Re: Revision of drill plan for MD-02, P-2014-003

Revised drilling plan MD02 P2014-003

Pad location for proposed drilling, Redcone Prospect

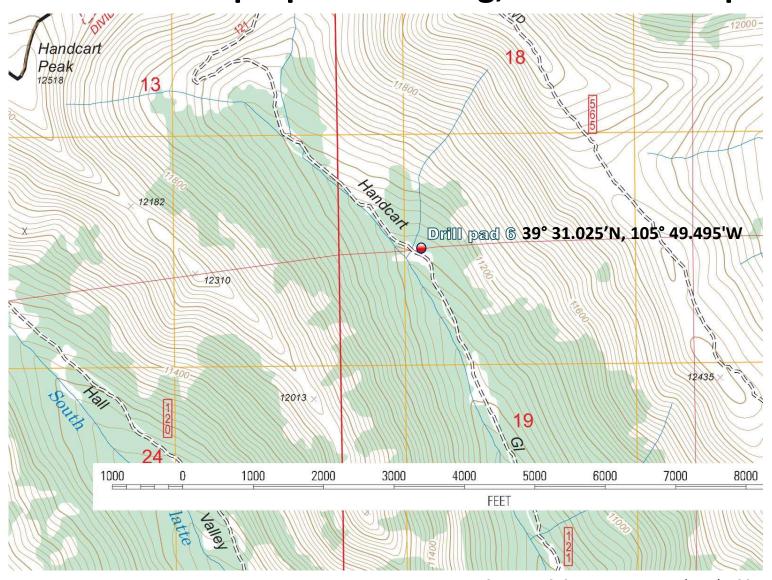
Sierta is eliminating construction of Pads 7 and 8 and all proposed drilling at those pads as indicated in its Sierta, LLC Notice of Intent to Conduct Prospecting Operations Modification MD-02, P-2014-003. In addition, Sierta plans to drill two additional boreholes on Pad 6; one to a nominal depth of 1,200 feet and the other to a nominal depth of 600 feet. The locations and trajectories of the revised drilling plan are shown on the attached maps.

Thank you for the revised project update. It looks like you are requesting that one of the additional two boreholes, as discussed and approved in the July 31st Project Update, increase from a nominal depth of 600 feet to 1,200 feet. The Division sees no issue with this request as it still falls within the scope and bonding of MD2. No further permitting is required for this change at this time.
